Product Change Notification / SYST-160WXP116

ERRATA - dsPIC33CH512MP508 Family Silicon Errata and Data Sheet Clarification Revision

dsPIC33CH512MP508 Family Silicon Errata and Data Sheet Clarification

FIGURE 1-1: I/O RAMP

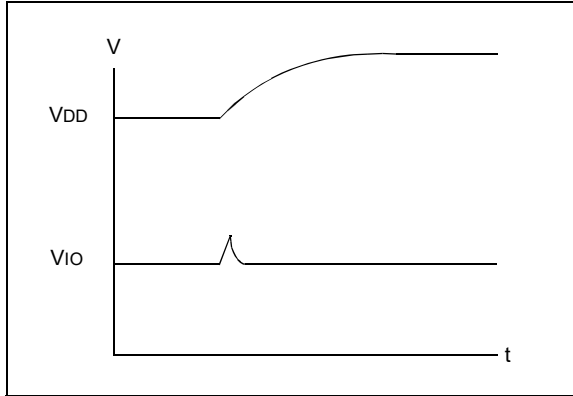
During a fast device power-up, when the VDD ramp is less than 4 mS, the I/O pins may drive up to 100 μ A current for a duration of up to 10 μ S (Figure 1-1).

Example applications affected may include complementary power switches, where a transient current shoot-through might occur. High-voltage applications with complementary switches should power the high-voltage 200 μ Sec later than powering the dsPIC[®] device to avoid the current shoot-through. This behavior is specific to each device and not affected by aging.

1. Slow down the VDD ramp time (greater than 4 mS for VDD to ramp 0V to 3.3V).
2. Ensure the circuitry that is connected to the pins can endure this pulse.

FIGURE 2-2: SUGGESTED PLACEMENT OF THE OSCILLATOR CIRCUIT

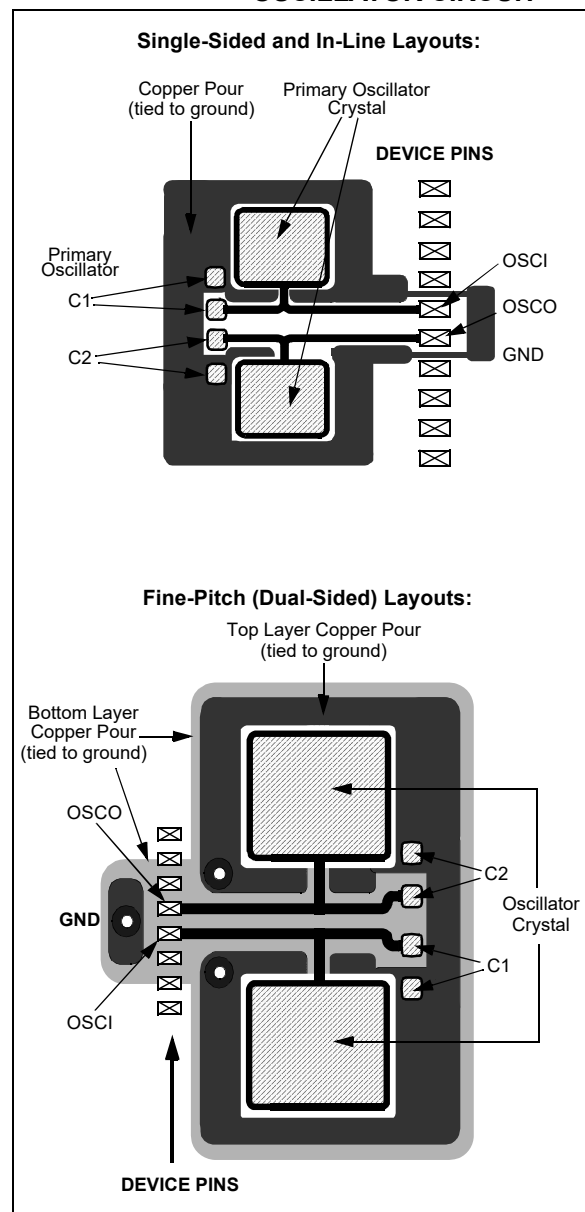
Additional information is added to [Section 2.5 “External Oscillator Pins”](#) and [Section 2.6 “External Oscillator Layout Guidance”](#) is added.

2.6 External Oscillator Layout Guidance

Use best practices during PCB layout to ensure robust start-up and operation. The oscillator circuit should be placed on the same side of the board as the device. Also, place the oscillator circuit close to the respective oscillator pins, not exceeding one-half inch (12 mm) distance between them. The load capacitors should be placed next to the oscillator itself, on the same side of the board. Use a grounded copper pour around the oscillator circuit to isolate it from surrounding circuits. The grounded copper pour should be routed directly to the MCU ground. Do not run any signal traces or power traces inside the ground pour. If using a two-sided board, avoid any traces on the other side of the board where the crystal is placed. Suggested layouts are shown in [Figure 2-2](#). With fine-pitch packages, it is not always possible to completely surround the pins and components. A suit-

FIGURE: ADC ANALOG INPUT MODEL

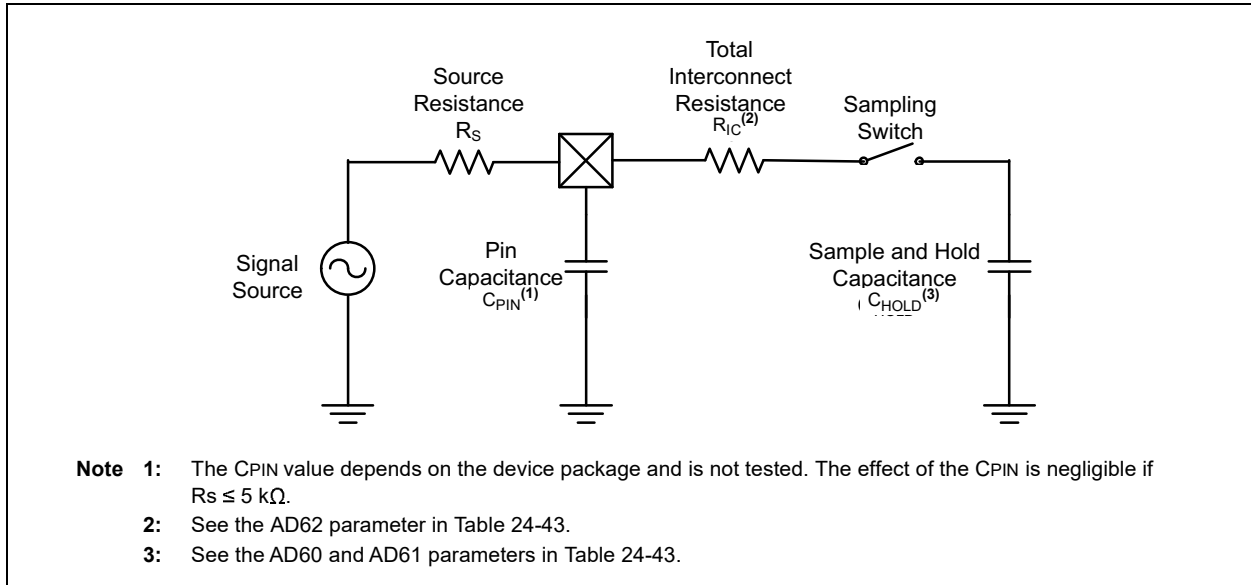
The following **Sampling Time Requirements** section has been added to both **Section 3.16 “High-Speed, 12-Bit Analog-to-Digital Converter (Main Core ADC)”** and **Section 4.7 “High-Speed, 12-Bit Analog-to-Digital Converter (Secondary Core ADC)”**.

The analog input model of the ADC is shown in the figure below.

FIGURE 21-4: FLASH SECURITY SEGMENTS (SINGLE PARTITION MODE)

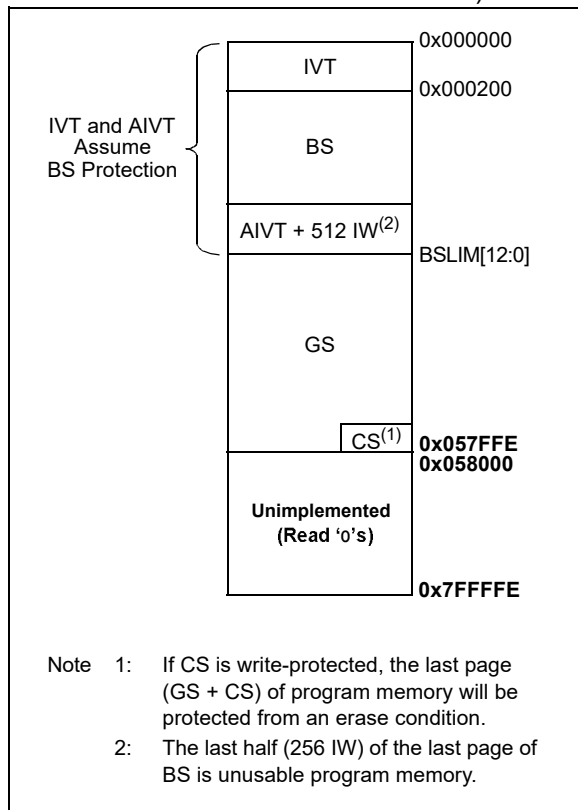
Figure 21-4 has been updated as shown in **bold** below.

FIGURE 21-5: FLASH SECURITY SEGMENTS (DUAL PARTITION MODE)

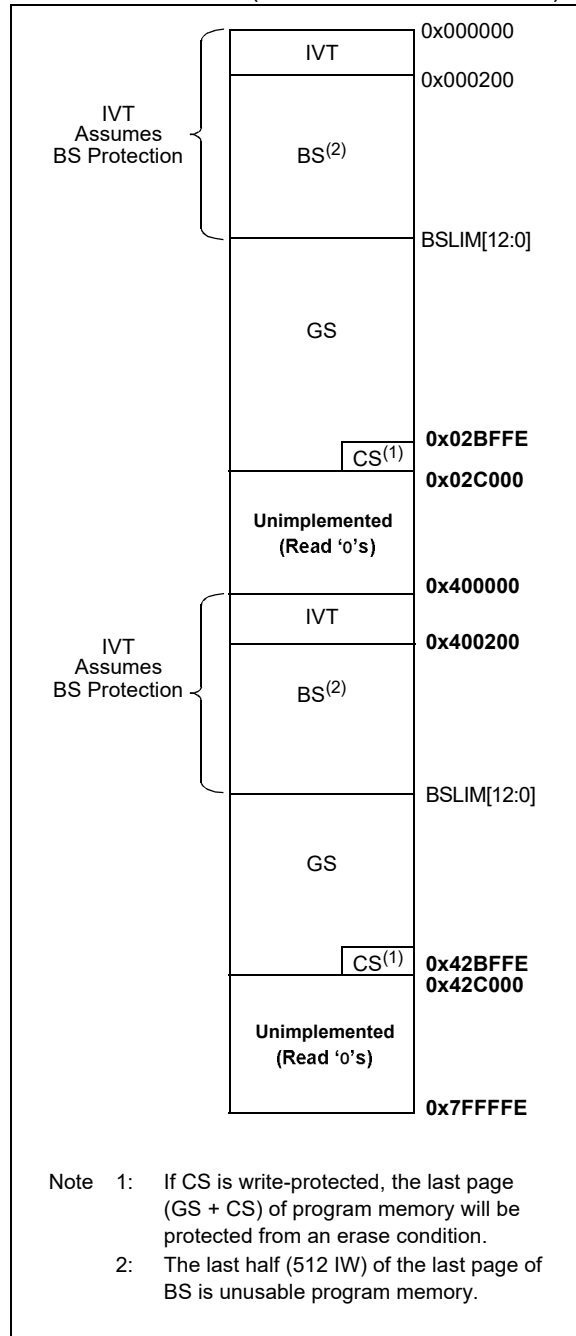
Figure 21-5 has been updated as shown in **bold** below.

FIGURE 4-3: PRAM (PROGRAM MEMORY) FOR SECONDARY CORE dsPIC33CH512MP508S1 DEVICES

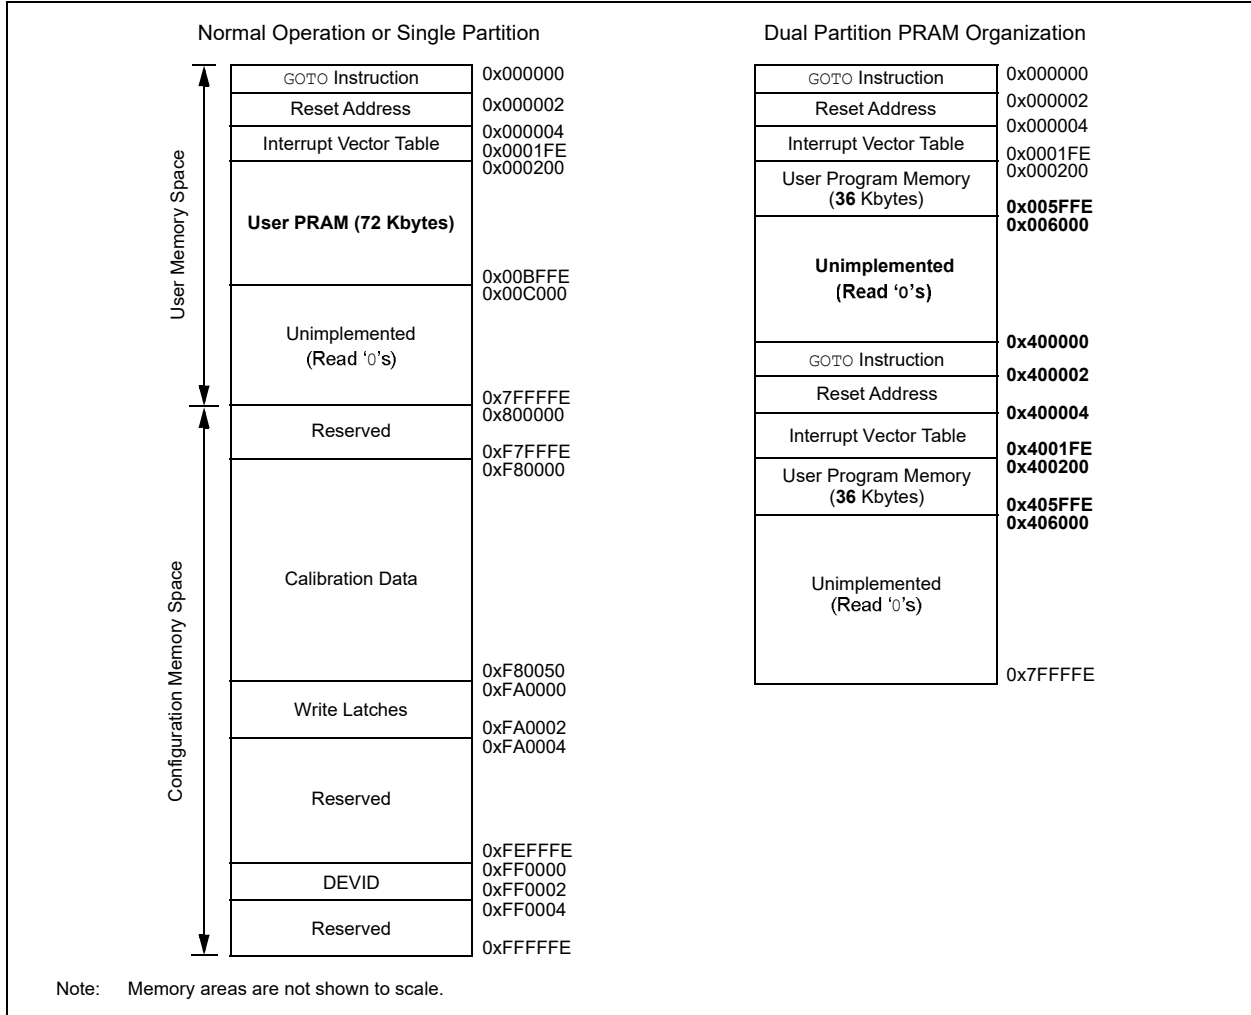
Figure 4-3 has been updated as shown in **bold** below.
